6030 HARVESTER SUPPORT CATCHERS UPGRADE KIT

PART NUMBER PC0004270

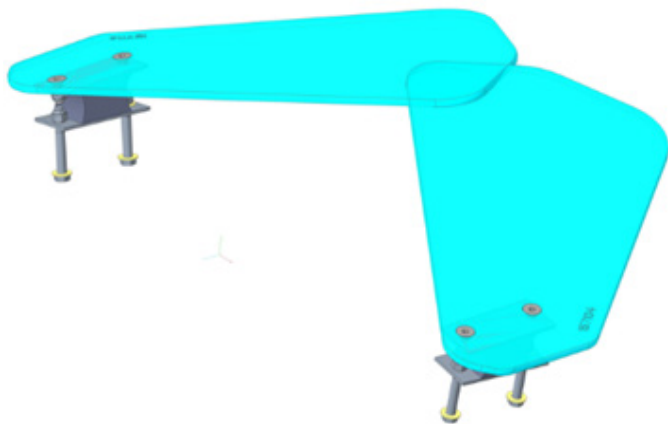
The large size of the rear most catcher plates may result in sagging overtime in heavy crop conditions. To prevent these catcher plates from sagging Oxbo offers an upgrade kit to add 2 additional support catchers just below the rear most catchers. With their smaller size they are able to be bolted to the existing catcher rail below and behind the Right and Left Rear Catcher plate assemblies. This upgrade will prevent unwanted sagging and help reduce unwanted fruit loss.

PC0004270 6030 Harvester Support Catchers Upgrade Kit must be installed with 167210 Torsion Block Catchers Option.
